**97-18-01 BELL HELICOPTER TEXTRON:** Priority Letter issued on August 19, 1997. Docket No. 97-SW-30-AD.

Applicability: Model 204B, 205A, and 205A-1 helicopters, with tailboom vertical fin spar, part number (P/N) 205-032-899, 205-030-846, or 205-030-851, all dash numbers, installed, certificated in any category.

Fig. 1  
AD 97-18-01

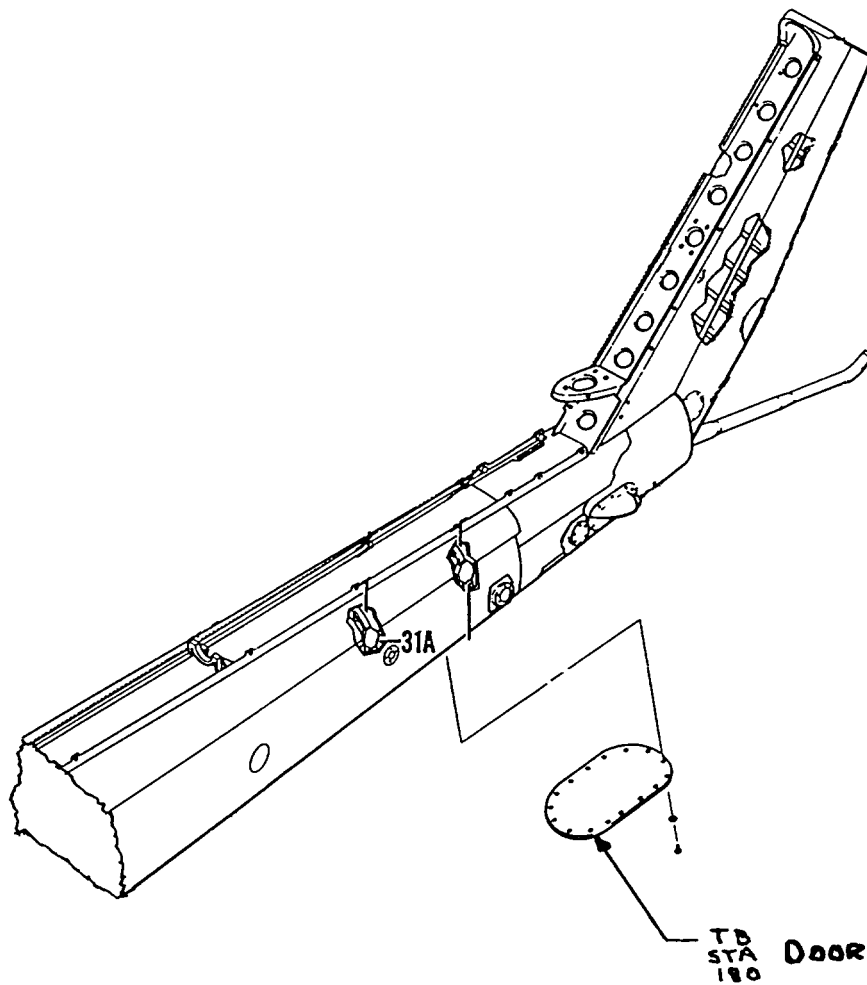
(1) Remove the lower aft tailboom inspection door, located at tailboom station 180 (see Figure 1).

Fig. 2

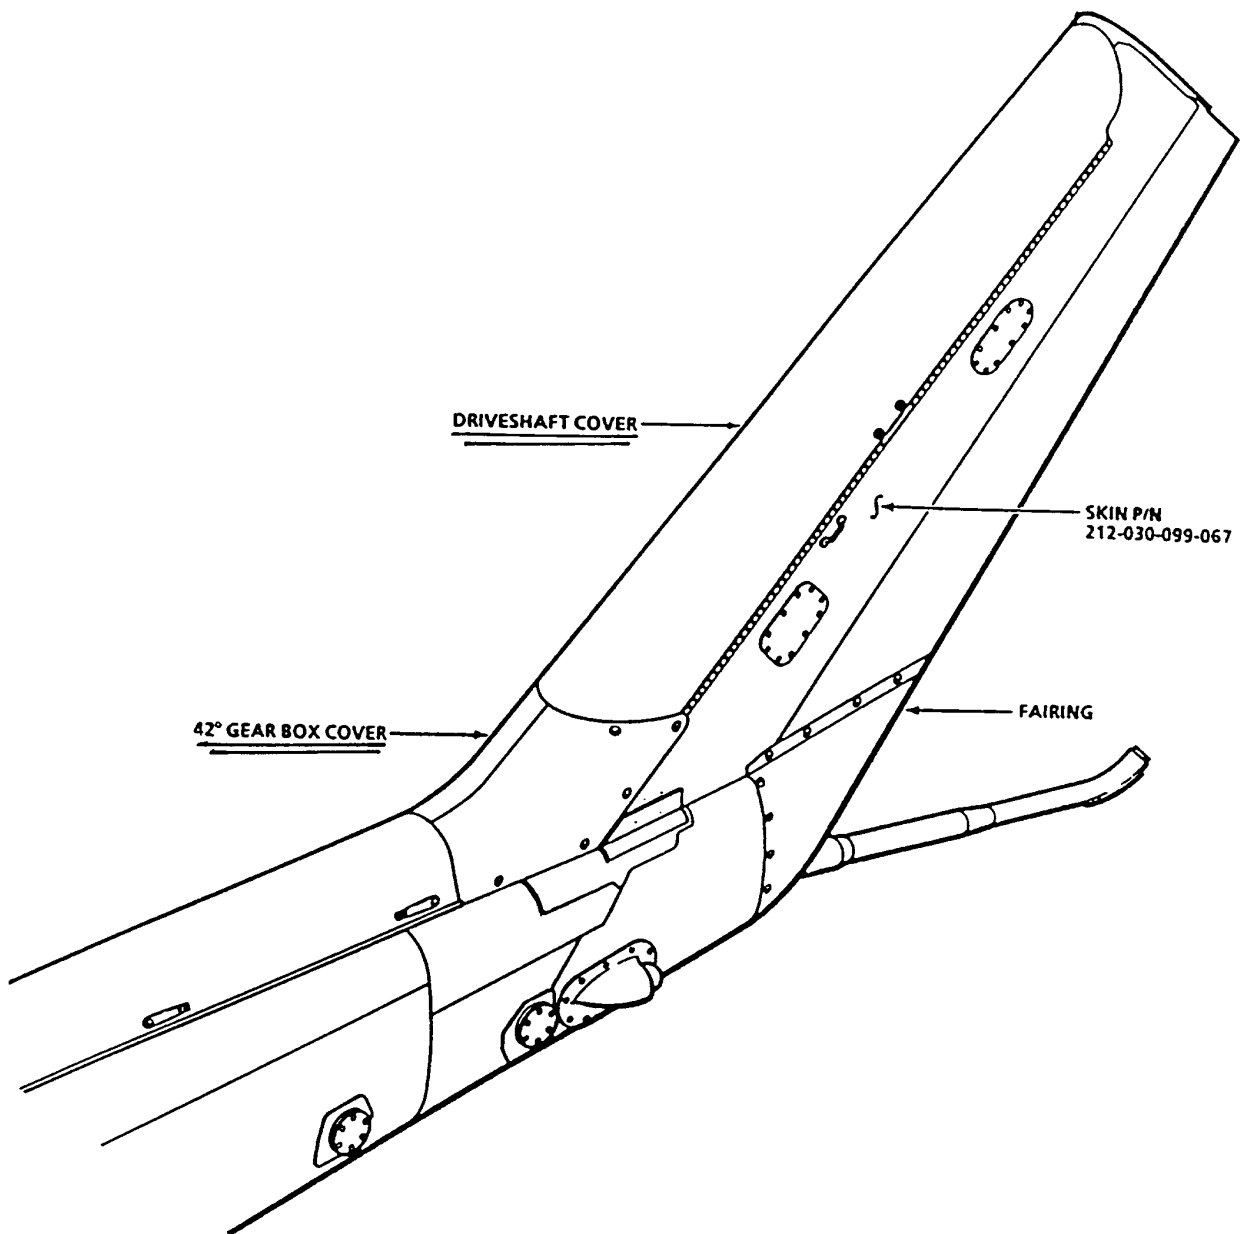
(2) Remove the 42° gearbox cover and open the drive shaft cover on the vertical fin spar (see Figure 2).

FIG 3 VIEW LOOKING INSD  
L/H SIDE

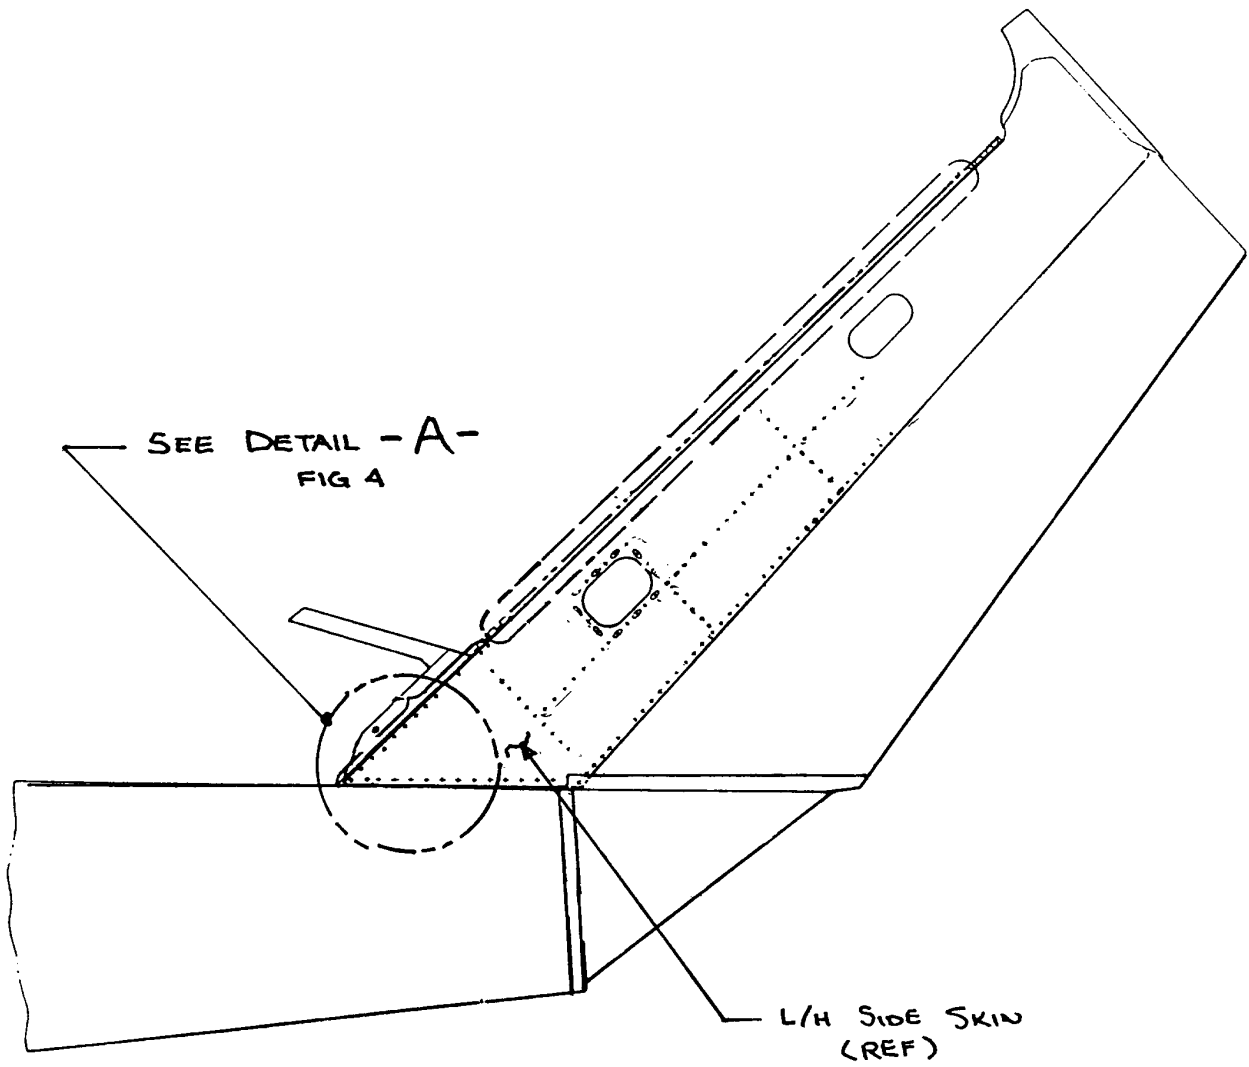
(3) Remove the clip, P/N 212-030-099-091, and the radius block, P/N 212-030-099-095 (see Figures 3 and 4). Remove the first four rivets from the bottom of the vertical fin spar left-hand side skin and retainer, P/N 205-032-851-045. Cut and remove the vertical fin spar left-hand side skin as shown (see Figure 5). CAUTION: Extreme care must be taken when drilling the side skin to ensure the vertical fin spar assembly is not damaged.

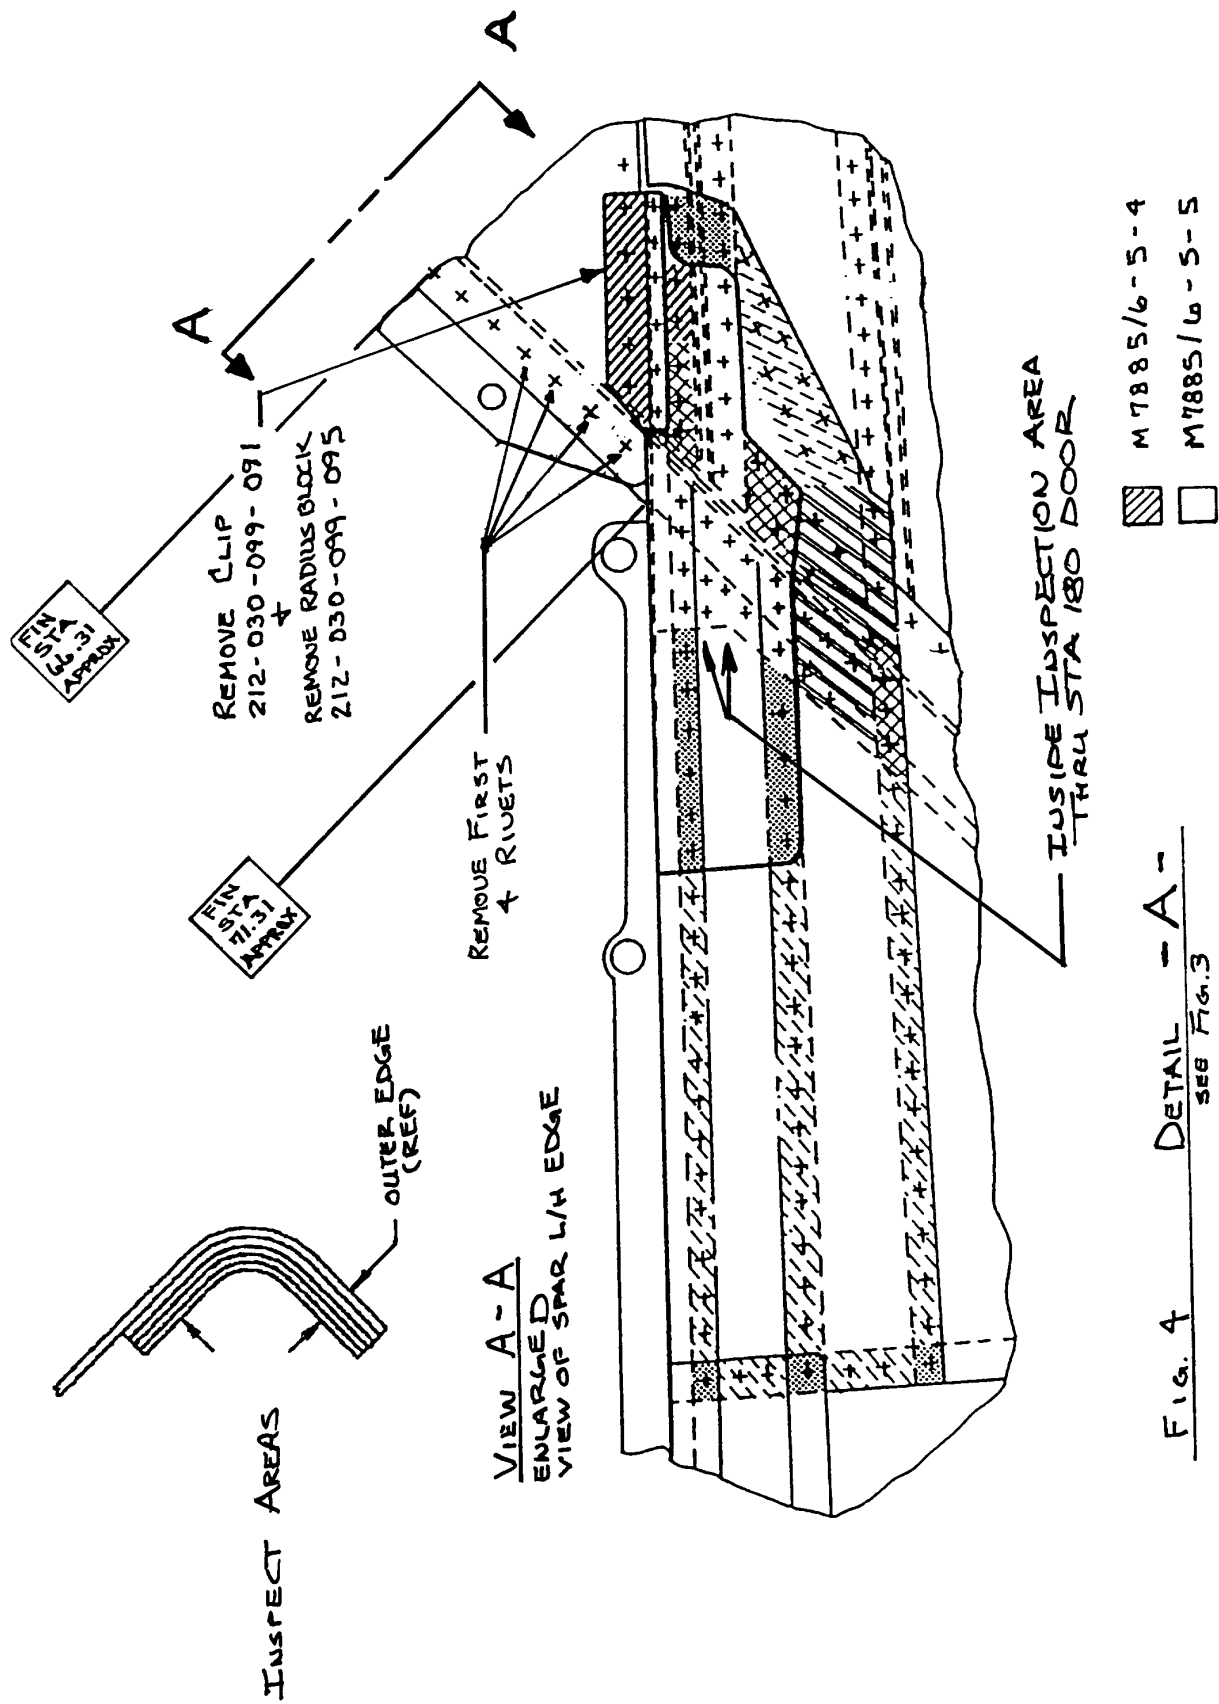
(7) Reinstall the clip and radius block (see Figure 4).

(1) Through the lower aft tailboom inspection door, using a bright light and an inspection mirror, inspect the vertical fin spar assembly adjacent to the tailboom top skin on the forward side, paying special attention to the left-hand edge and the adjacent surfaces (see Figure 4).

(2) In a ventilated work area, clean all surfaces to be inspected with a cloth dampened with aliphatic naphtha or an equivalent cleaning solvent. Using a bright light and a 10x magnifying glass, inspect the vertical fin spar assembly adjacent to the tailboom top skin, on the inboard and outboard sides, the vertical edge, and the two open rivet holes. Using a bright light and a mirror, inspect the aft side of the vertical fin spar in the same area. Special attention must be given to the left-hand edge of the vertical fin spar and any adjacent surfaces between fin station 66.31 and 71.31 (see Figure 4).

FIG. 5  
 VIEW LOOKING INWARD  
 LEFT SIDE

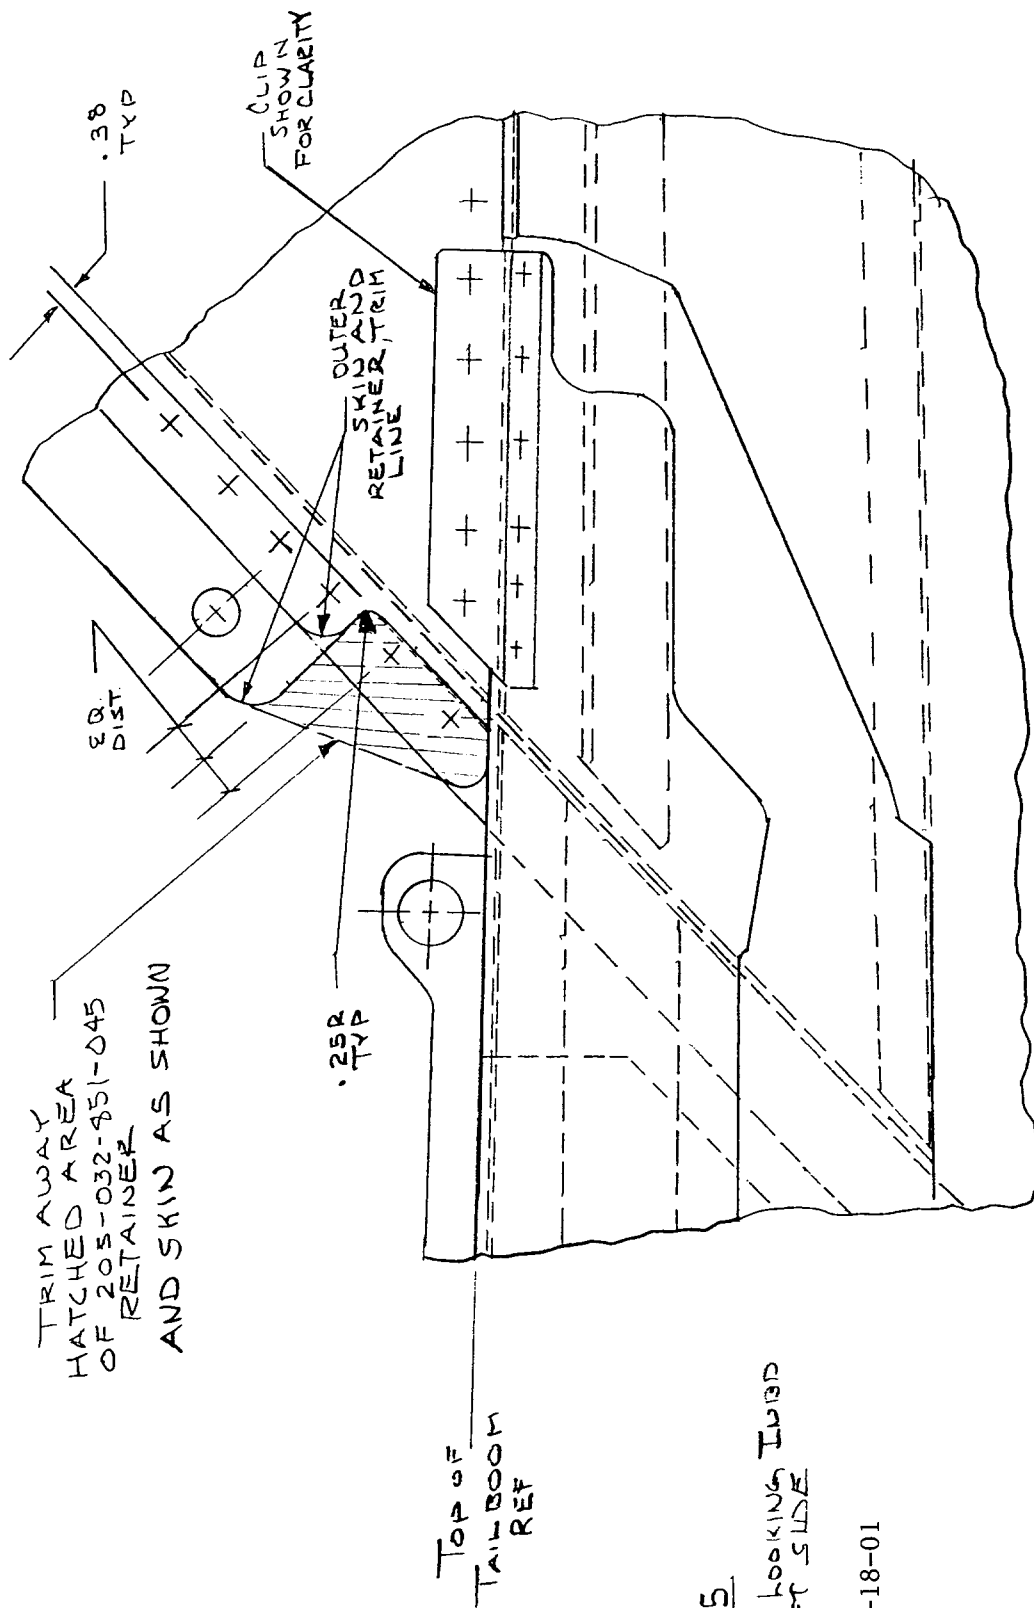
(4) Trim the retainer using extreme care to not damage the vertical fin spar assembly (see Figure 5).
